# SERVICE BULLETIN

M-1397A

## NON-COMPLIANCE RECALL CODE 0619 ACCESSORY LED REAR BULLET TURN SIGNAL KIT

**Figure 1. Rear Lighting Wiring**

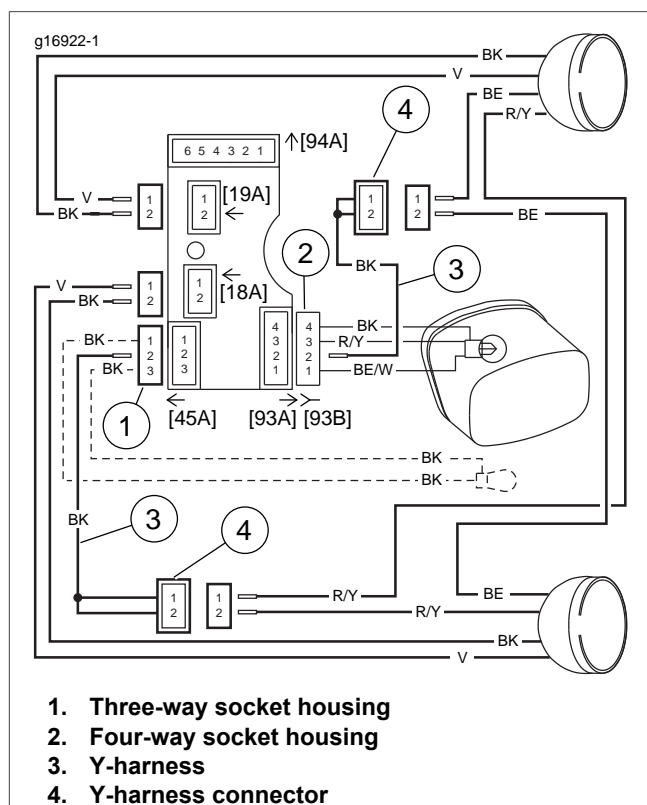
See Figure 1. Leave Y-harnesses (3) connected to the tail lamp circuit board. Do not disconnect three-way socket housing (1) or four-way socket housing (2).

3. Discard Y-harnesses from kit.
4. Disconnect Y-harness connectors (4).
5. Install remainder of kit using Isheet -J04989 LED Rear Bullet Turn Signals.
